# DEVELOPMENT REVIEW BOARD REPORT

CASE NUMBER/ PROJECT NAME	<b>24-DR-1992#6 Camelback Desert School Bldg G</b>		
LOCATION	9606 E Kalil Drive		
REQUEST	Request approval of site plan & elevations for construction of a new classroom building.		
OWNER	U S S Benson LLC 602-571-1016	ENGINEER	Morea Hall Engineering Inc 602-258-4428
ARCHITECT/ DESIGNER	Art & Space Architects 480-949-0204	APPLICANT/ COORDINATOR	Richard Sherman Art & Space Architects 480-949-0204

# **Stipulations for Case: Camelback Desert School Building G Case 24-DR-1992#6**

CONCEPTUAL LANDSCAPE PLAN  
Jana Brackley, Landscape Architect, A.S.L.A.  
P.O. Box 1584, Scottsdale, Arizona 85262 602.910-0007

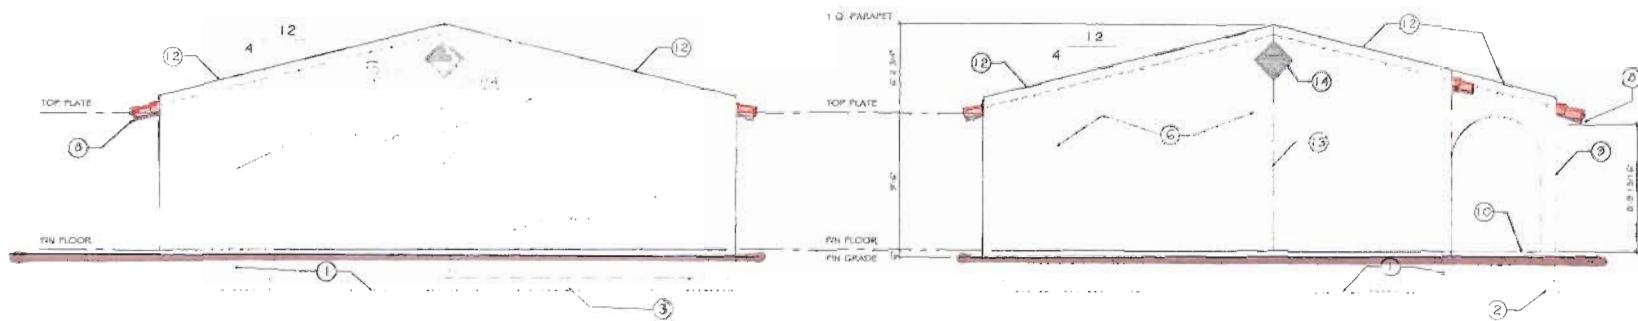
- c. Landscaping, including quantity, size, and location of materials shall be installed to be consistent with the conceptual landscape plan submitted by Joan Brooking, dated 2-21-05, and submitted to the City on 3-09-05.

SOUTH ELEVATION

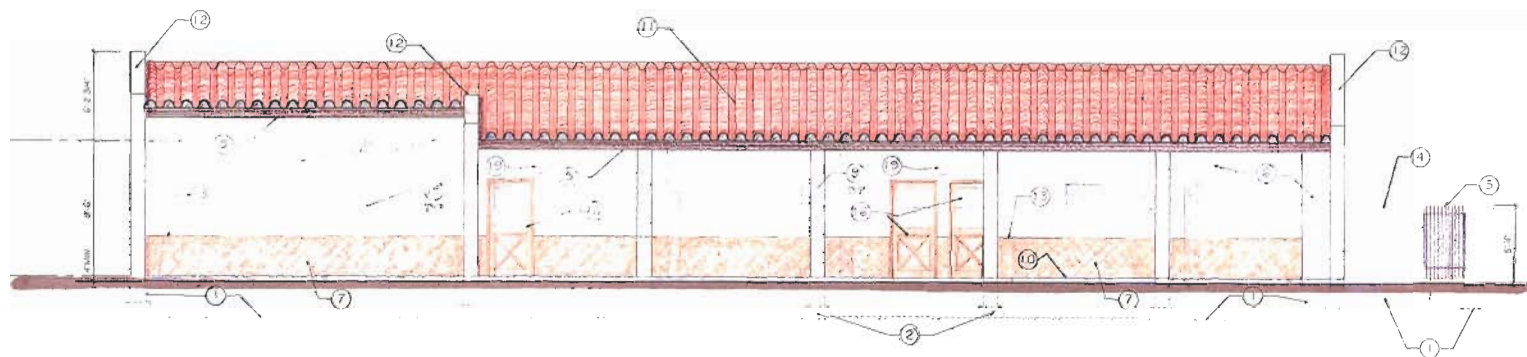
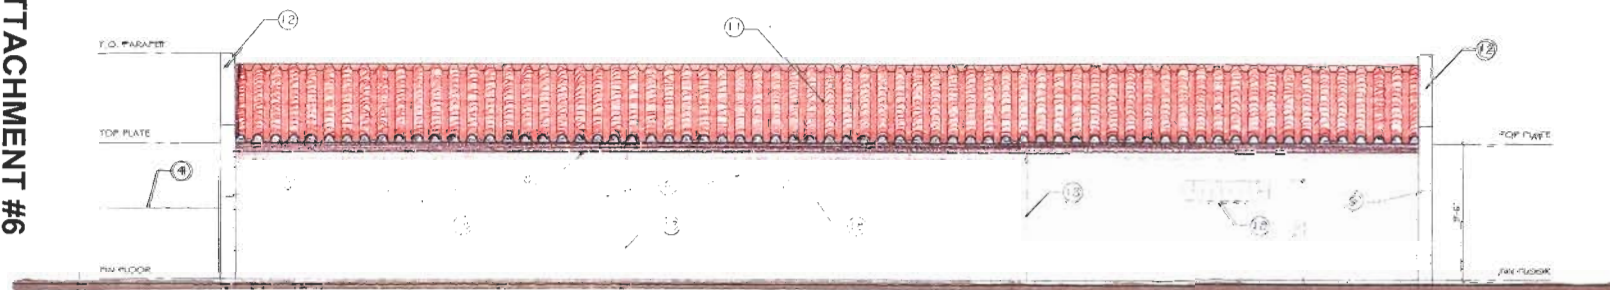
- a. Architectural elements, including dimensions, materials, form, color, and texture, shall be constructed to be consistent with the building elevations submitted by Art & Space Architects, LTD., dated 2-28-05, and submitted to the City on 3-09-05.
